Re: Section 16 Planning Application for Proposed Temporary Cold Storage for Poultry and Distribution Centre for a Period of 3 Years and Filling of Land for Site Formation Works at Lots 471 S.B RP (Part), 472, 473, 474, 475, 476, 483, 501, 502, 504 S.B, 505 and 506 S.B RP in D.D. 89 and Adjoining Government Land, Man Kam To Road, Sha Ling, New Territories

We submit herewith Further Information (FI) with 4 copies of Responses-to-Comments Table with Appendices for the consideration by relevant Government departments or Town Planning Board.

Table 1	Response-to-Comments
Appendix 1	Revised Planning Statement
Appendix 2	Revised Environmental Assessment
Appendix 3	Revised Drainage Impact Assessment
Appendix 4	Figure RC-01

Figure 3-2: Indicative Proposed Drainage Layout

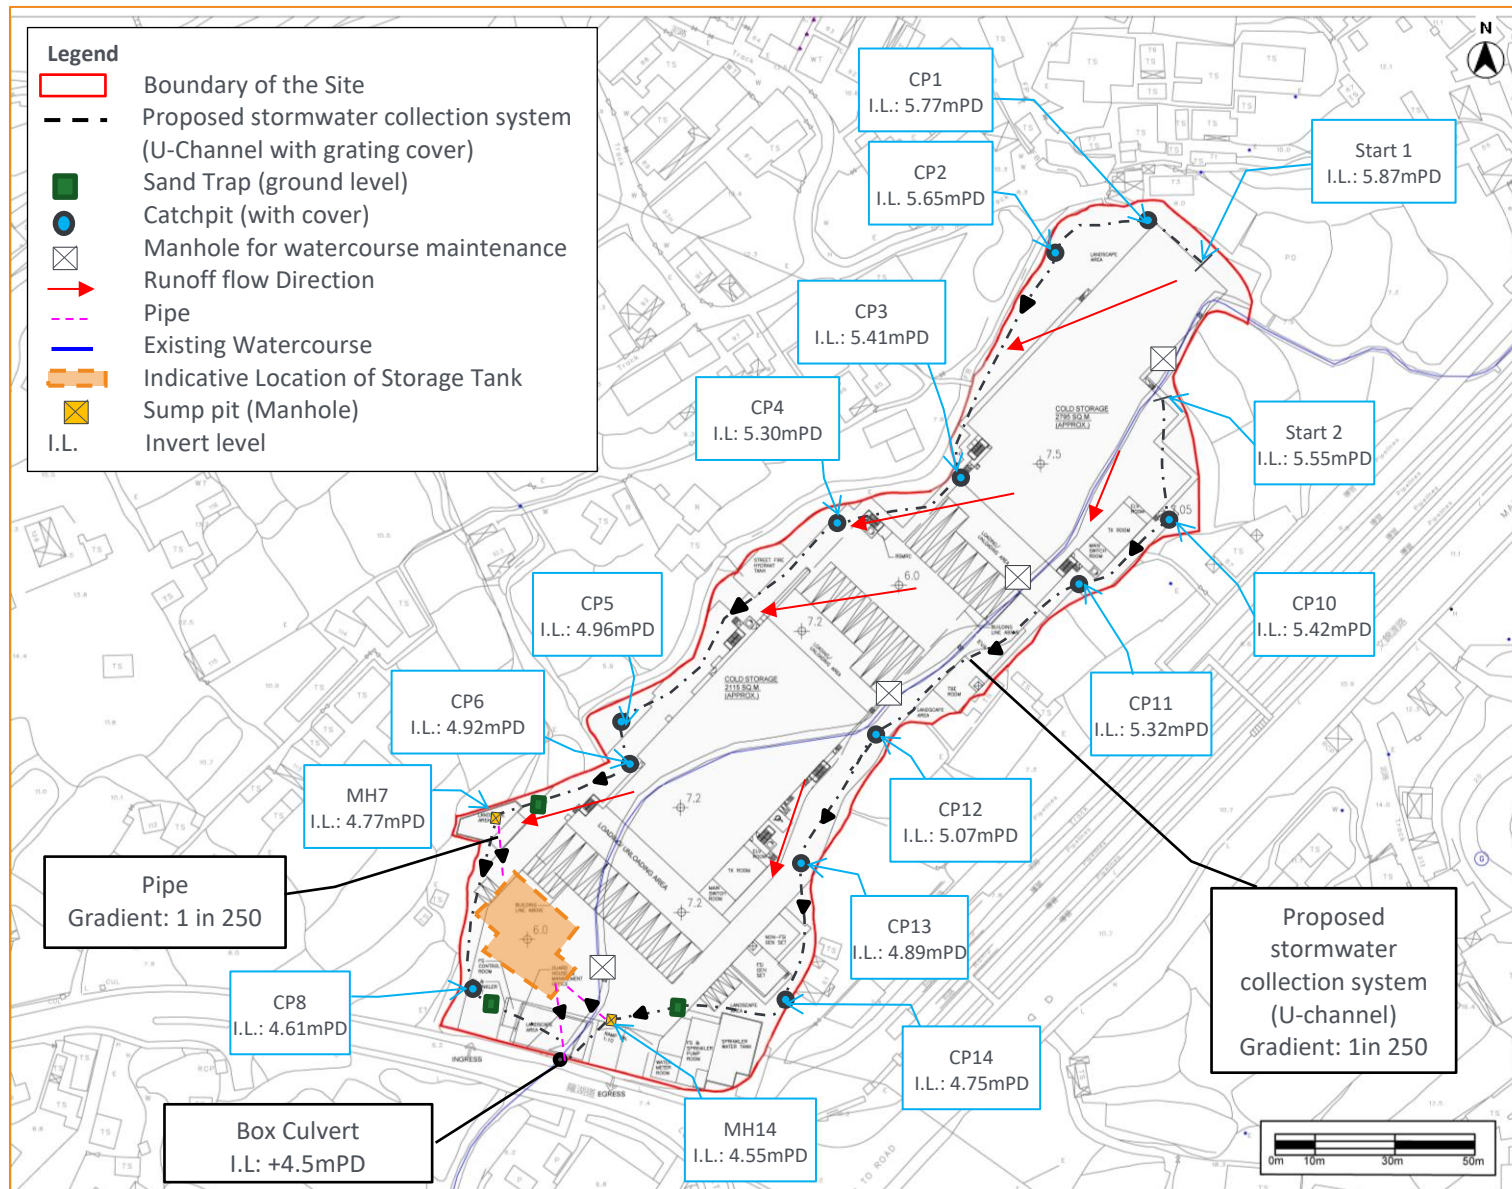
<p>6. Figure 3-2 refers.</p> <p>i. Please provide future ground levels to substantiate the flow</p>	<p>Please refer to Appendix 3.</p> <p>i) The indicative future ground levels are indicated in Figure 3-2</p>

Figure RC-01

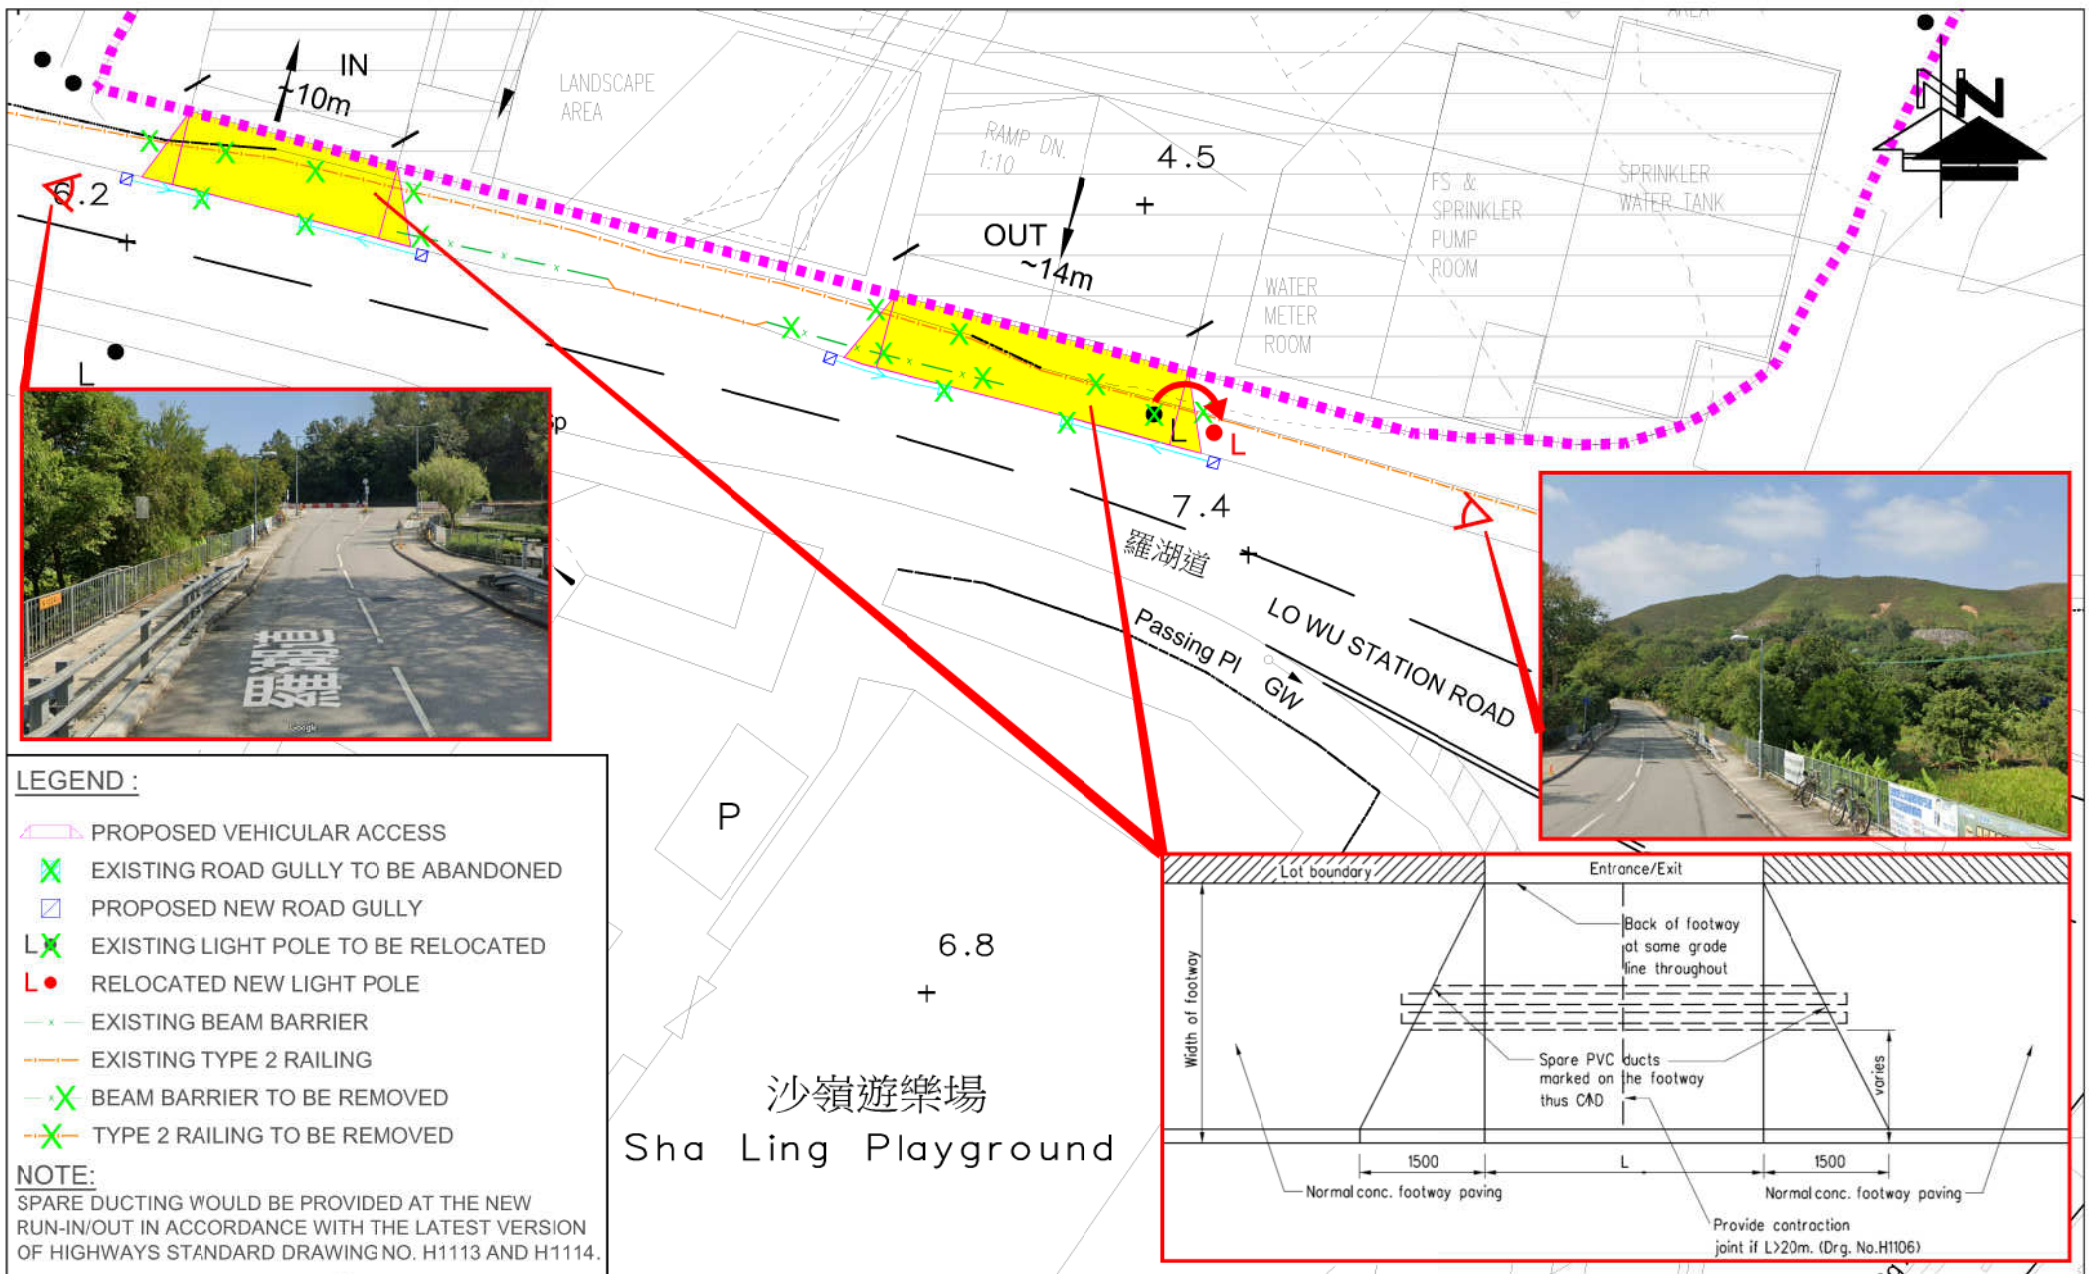
<p>2. Para. 4.6.1: As the existing railings and beam barriers will be</p>	<p>Noted. Please find the attached Figure RC-01 for your information</p>
